TECHNICAL BULLETIN

[Issue No.] T40-0007

[Title] Corrections in the QnPRHCPU User's Manual
(Redundant System)

This bulletin provides information on corrections due to clerical errors in the program examples of the QnPRHCPU User's Manual (Redundant System) (SH-080486ENG) of "version F (printed in June, 2006)".

- (1) Section 7.1 (1) (b) [Diagram 7.2 Example of REMFR instruction programming]

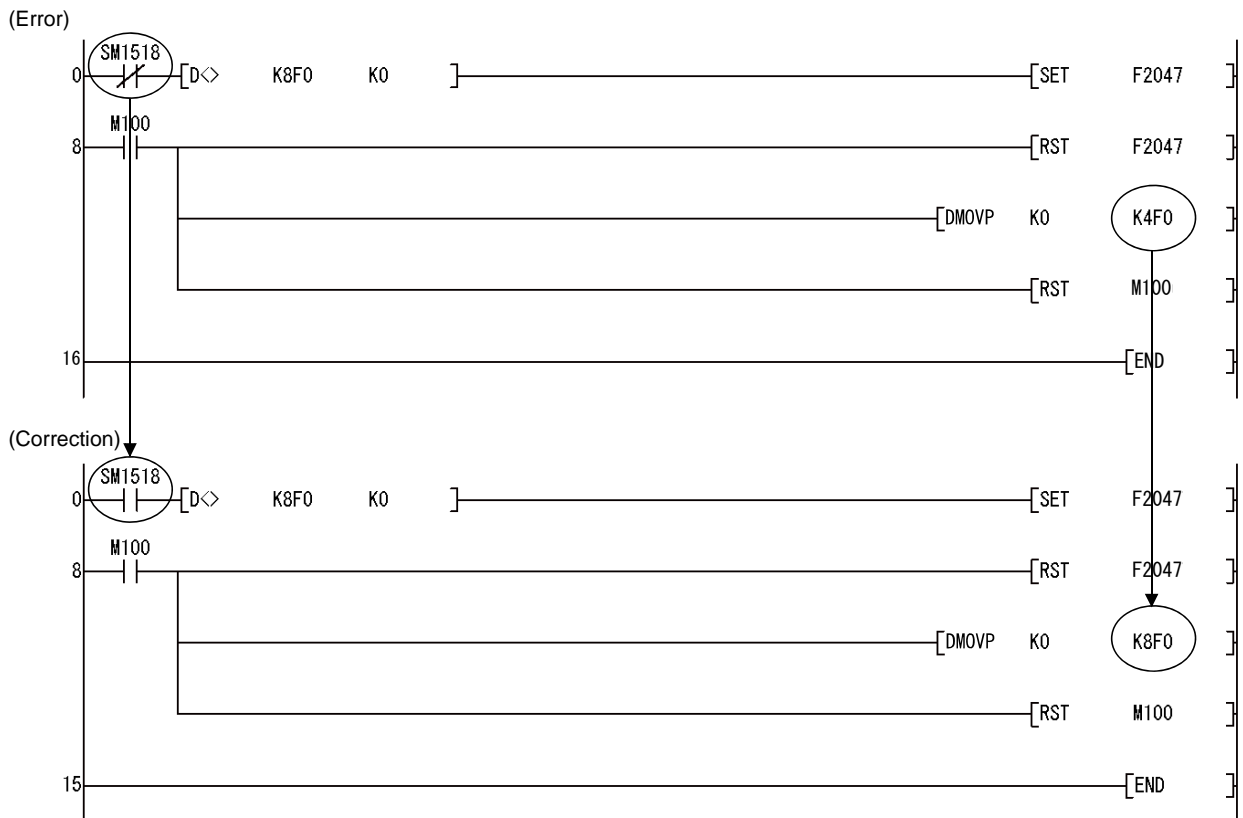
The setting condition for the host data link status has been corrected in the example of a program for reading intelligent function module data of the remote I/O station using the REMFR instruction as shown below.

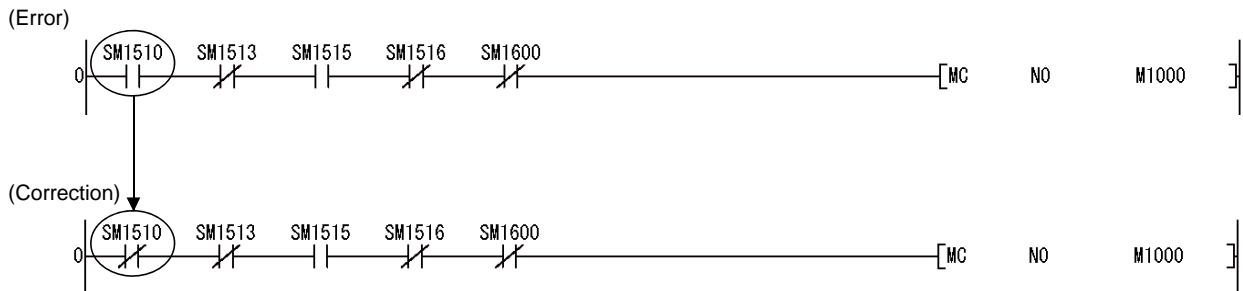
- (2) Section 7.3 (1) [Diagram 7.13 Program That Turns on the "USER" LED after System Switching]
 The SM1518 contact and the storage destination device of the DMOV instruction have been corrected in the example of a program for turning ON "USER" LED on the CPU module in the new control system after switching as shown below.

(5) Appendix 5 (2) [Diagram App.20 A program example]

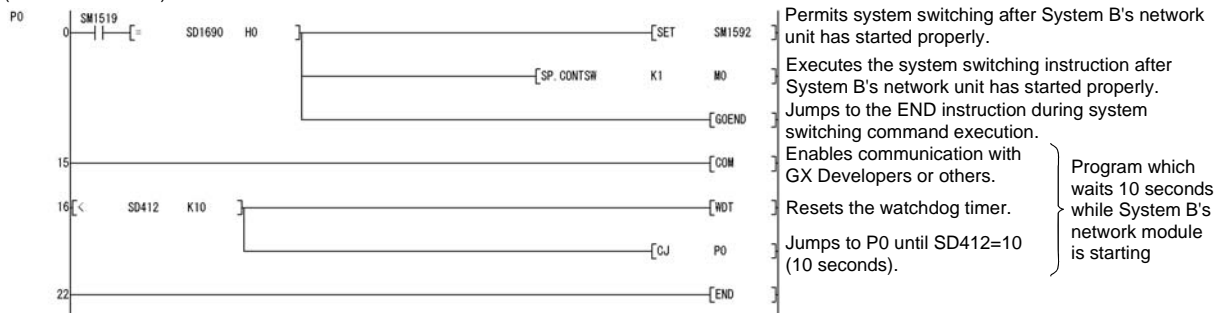
1) Operation of the program before correction

When 32768 seconds (around 9.1 hours) elapses after the CPU module became RUN status, SD412 value will be -32768. In the following program (before correction), since the processing is repeated in the relevant program until the SD412 value will be 10 or more again (around 9.1 hours), other sequence operations cannot be performed. Note when this occurs, the CPU module will not be STOP status even the RUN/STOP switch is set from RUN to STOP.

The method for starting with the previous control system has been corrected in the example of a program when mounting a network module to the base unit as shown below.
